Re: Supplemental Photos, Marlboro Apartments, 1031 Marlborough, Detroit, MI

CONTINUATION/AMENDMENT SHEET
Historic Preservation
Certification Application

**MARLBORO APARTMENTS
BUILDING RENOVATION**

REFLECTED CEILING PLAN, AVAILABLE
PIPING CHASES, BASEMENT CORRIDOR
1/4" = 1'-0"

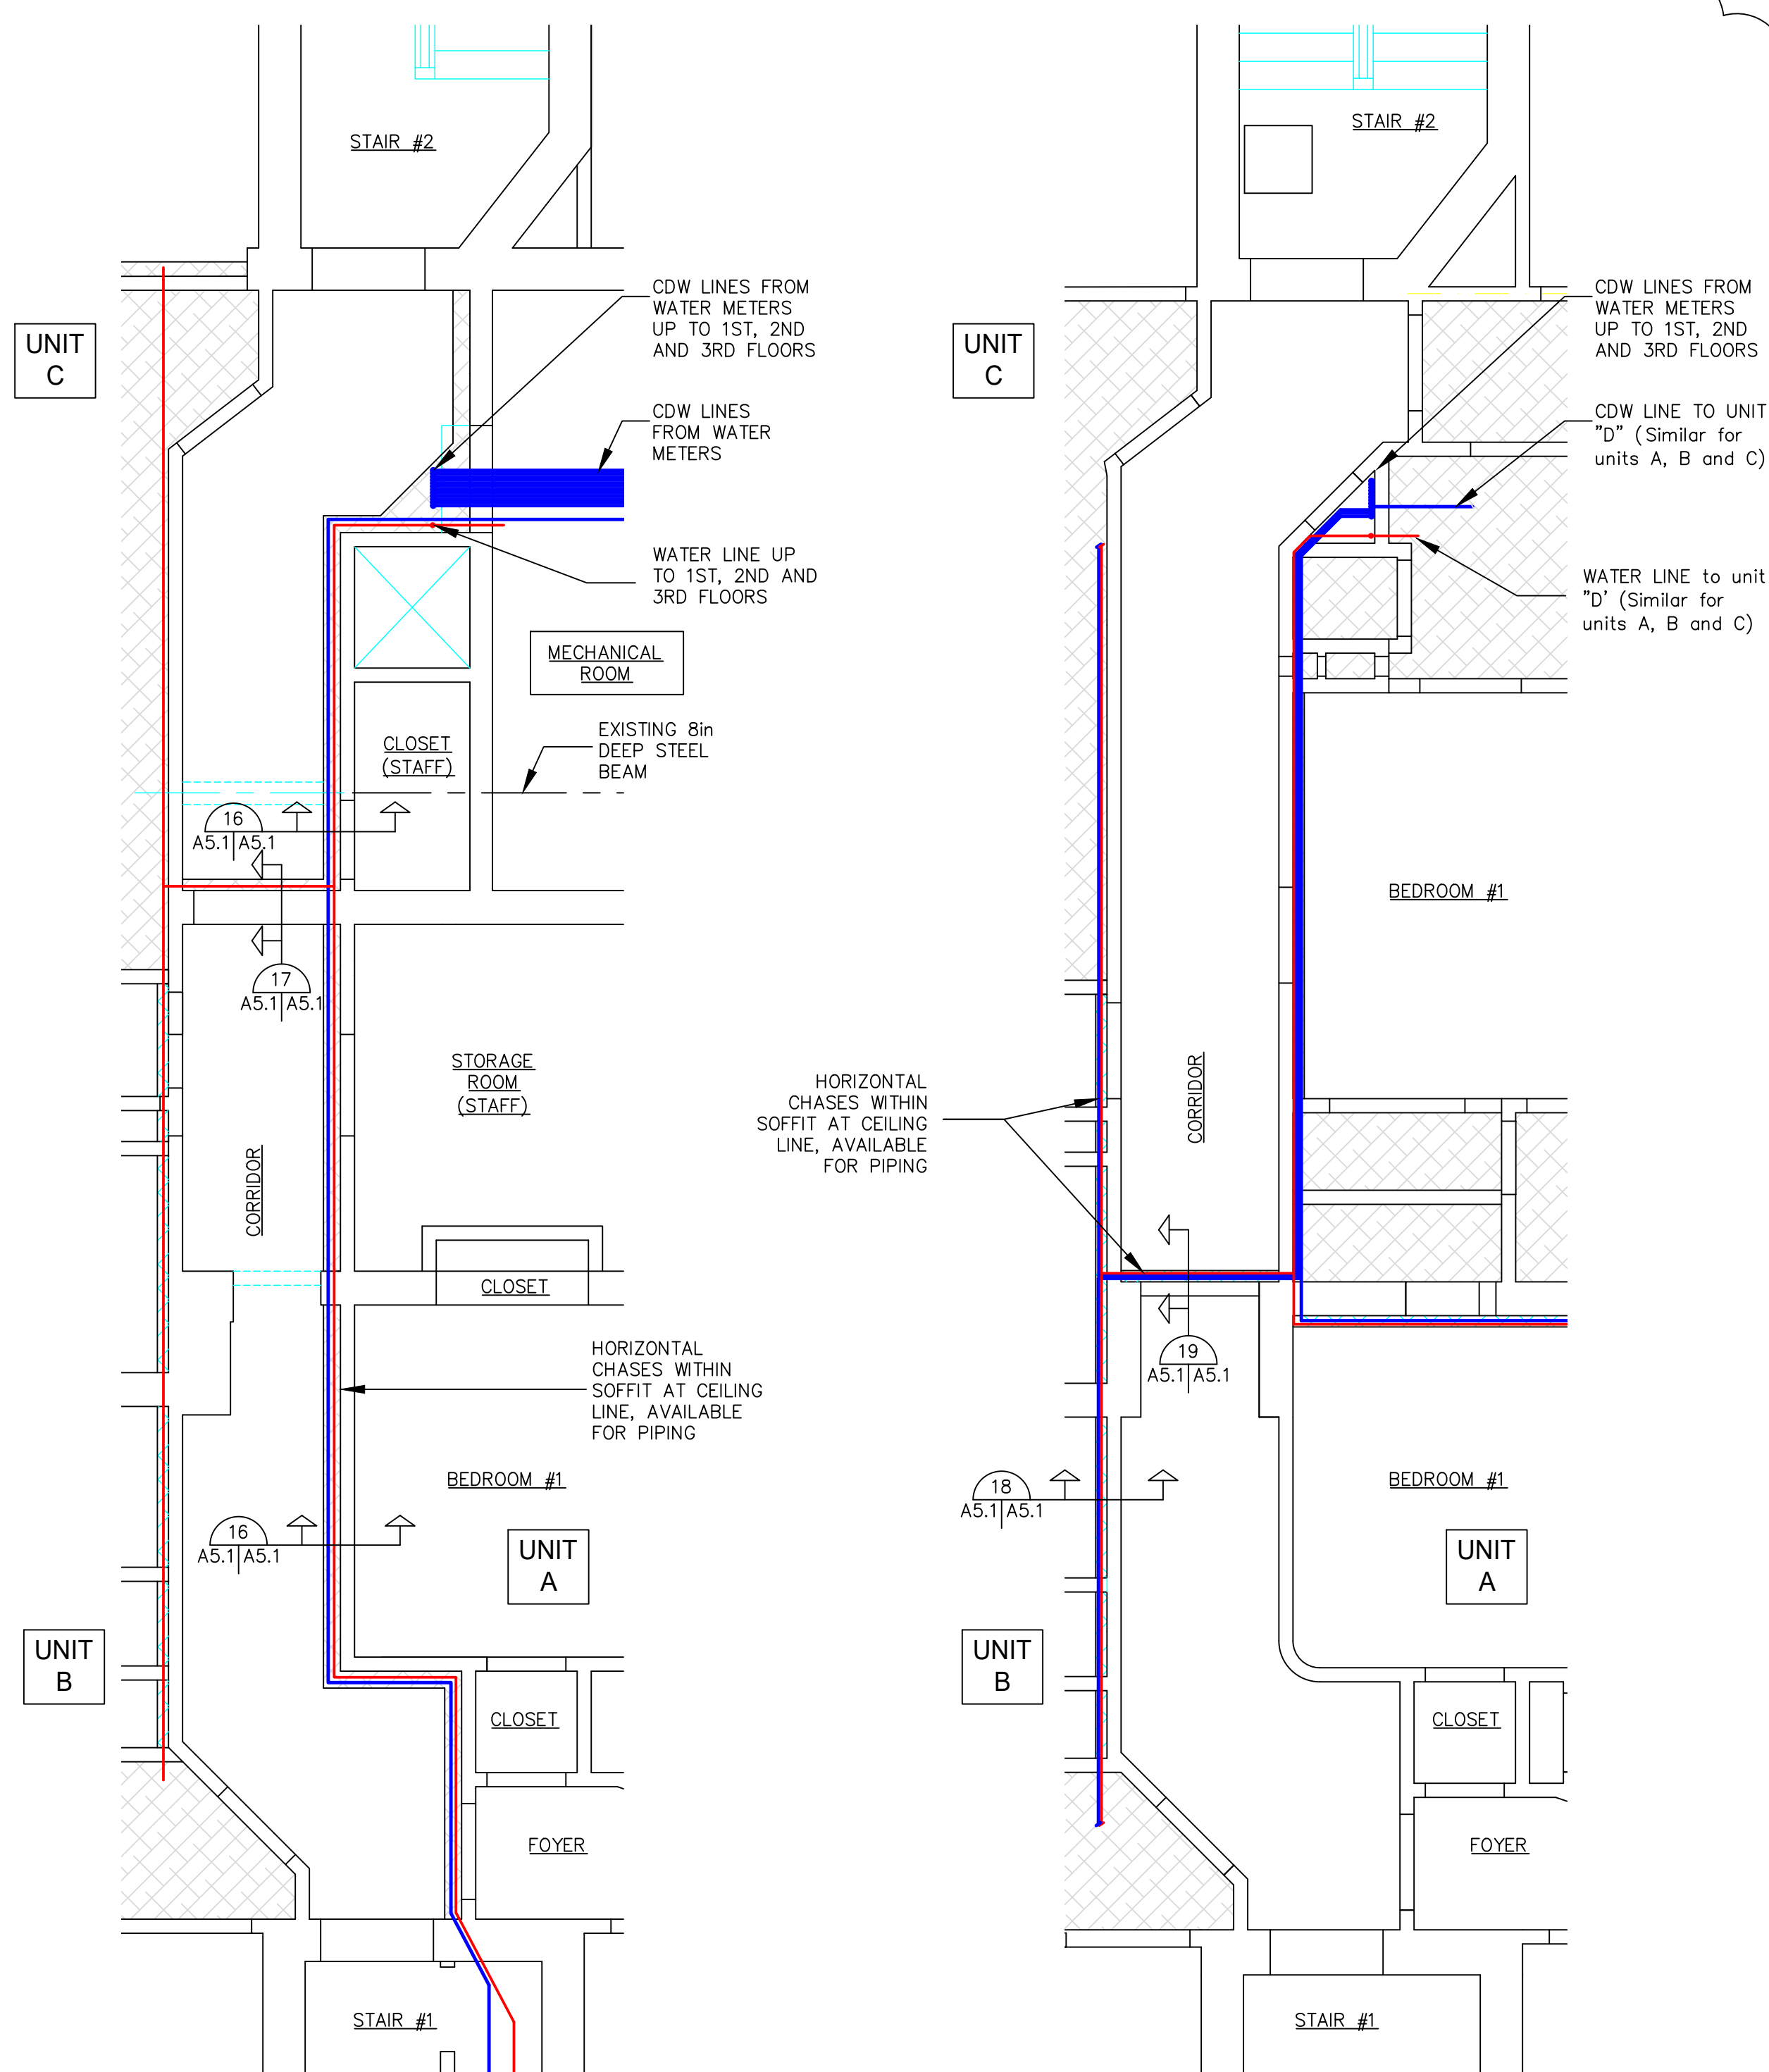
REVISIONS THIS SHEET	
	ADDED OVERLAY OF PIPE RUNS IN SOFFITS TO SHOW AVAILABLE PIPING ROUTES WITHIN ENCLOSED HORIZONTAL CHASE.
